CITY OF RIVERSIDE CALIFORNIA
DEPARTMENT OF PUBLIC WORKS

DWIGHT AVENUE
CURB AND GUTTER
BETWEEN
MINNESOTA ST. & LINDEN ST.

R-157

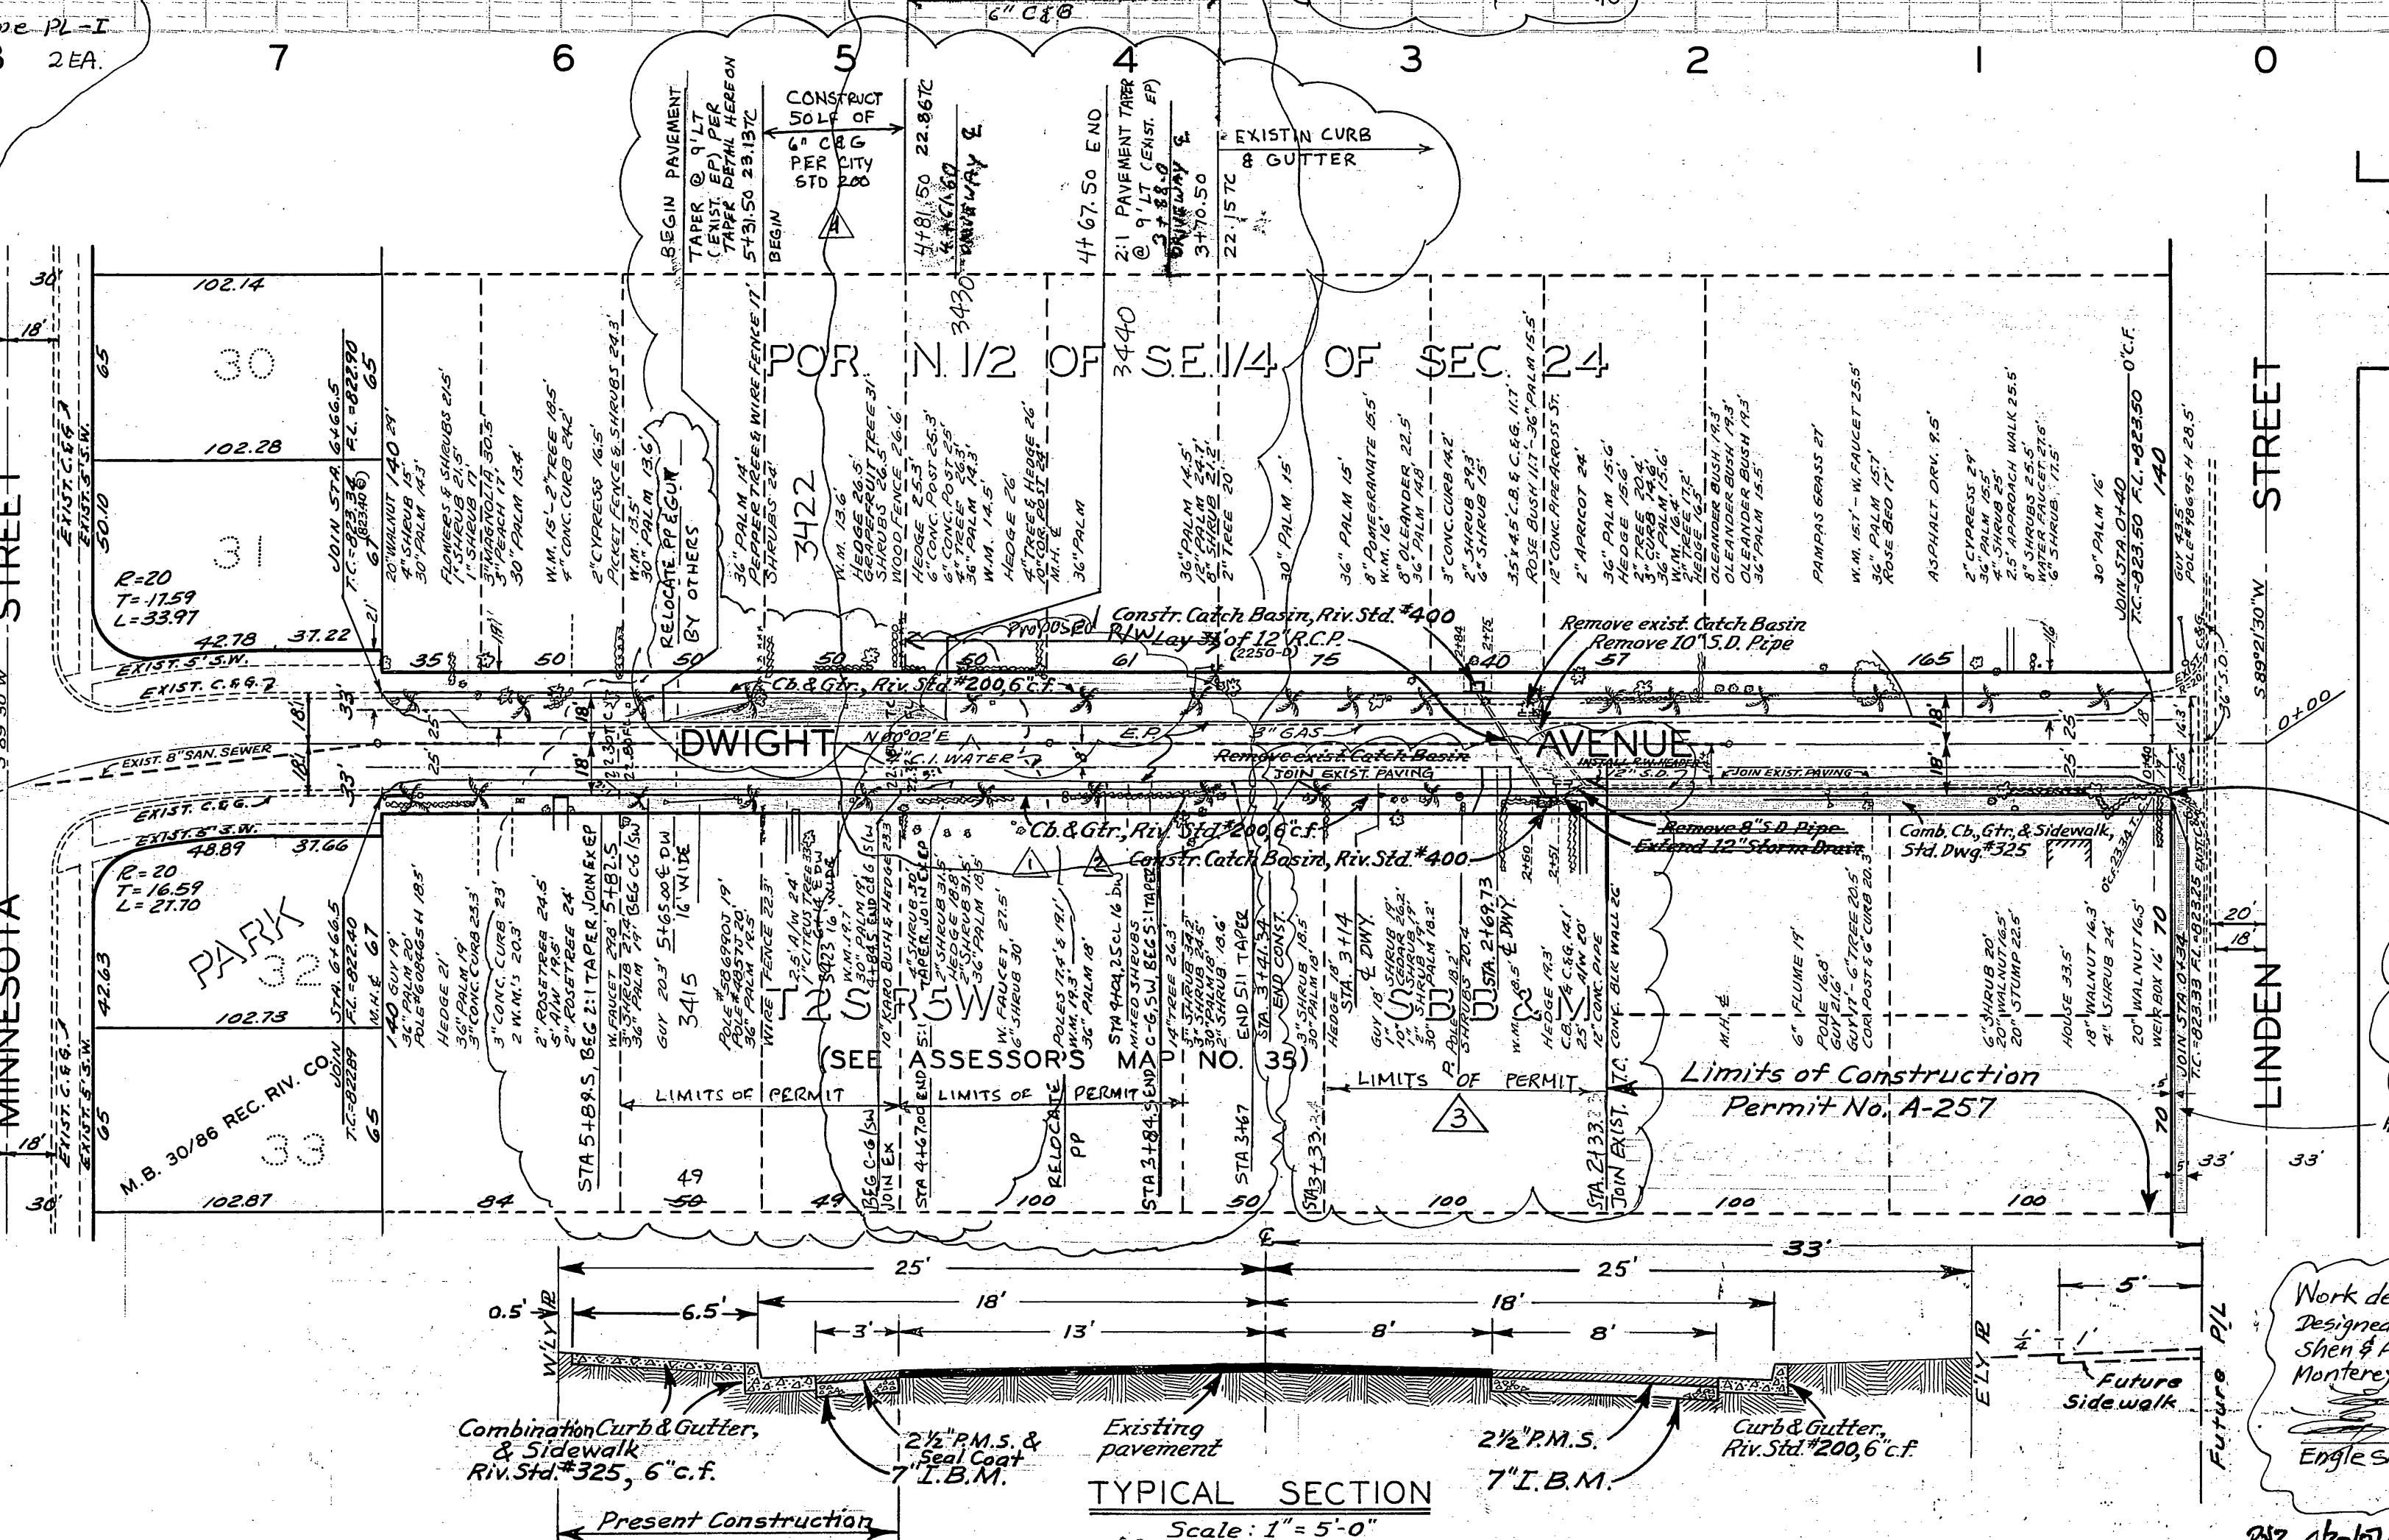
- ① iii. Driveway Approach per City of Riverside Std. 302 Type PL-I for 3440 Dwight Ave @ STA. 3+88.00
A = 18', B = 25'
 - ② For 3430 Dwight Ave @ STA. 4+61.60
A = 16', B = 23'
 - ③ Curb & Gutter per City of Riverside Std. 200, Type 1 6" CF
 - ④ P.L. sidewalk per City of Riverside Std. 325, Type 1 555 SF
 - ⑤ Cold Plan Var. Thickness AC Class C2 - AR-4000, 2" min 1320 SF
- work defined by revision No. 4 on this sheet designed under the direction of Mahid Behnawa
- For NB&H Engineering Inc.
28491 Rancho California Road, suite 105
Temecula, CA - 92590

- ① CONSTRUCT 23' WIDE DRIVEWAY PER CITY STD. 302 1 EA
 - ② APPROACH A = 23' B = 25'
 - ③ CONSTRUCT CURB AND GUTTER PER CITY STD. 200 50 LF
 - ④ TYPE 1 6" CF
 - ⑤ CONSTRUCT P/L SIDEWALK PER CITY STD. 325 300 SF
 - ⑥ CONSTRUCT 4" AC C2-AR-4000 OVER 6" CAB 670 SF
- WORK DEFINED UNDER REVISION NO. 4 ON THIS SHEET PREPARED UNDER THE DIRECTION OF JOHNNY GAYMAN @ COLLINS & ASSOCIATES ENGINEERING INC.
6840 INDIANA AVE SUITE 230 RIVERSIDE CA 92506 PH: (951) 275-0966
- Johnny Gayman 3/22/07
JOHNNY GAYMAN DATE

1. DRIVEWAY Approach Sta. 3+14 A=16', B=23' Sta. 2+67.3 A=10', B=17'

4. Cold Plan Var. Thickness A.C. Class C2-AR-4000, 2" Min. 1275 SF

5. Remove Exist. A.C. Pavement and Reconstruct 4" A.C. Pavement, C2-AR-4000 ON 6" C.A.B. 606 SF

MARK	DATE	DESCRIPTION
1	11-19-57	Grade change, both sides, and
2	12-9-57	Location of Sidewalks 216
3	10-30-59	Const. shown for Permit #A-257
4	6-15-03	ADDED C&G, STA 4+84.5 TO 5+81.5
5	2-22-04	ADDED C&G, STA 3+49.5 TO 4+84.5
6	2-05-07	REVISION OF B
7	10-14-06	ADDED STATIONS OF PROPOSED DRIVEWAY PLAN & PROFILE, ADDED C&G, SIDEWALK & PAVING STATION STA. 2+33 TO STA. 3+33
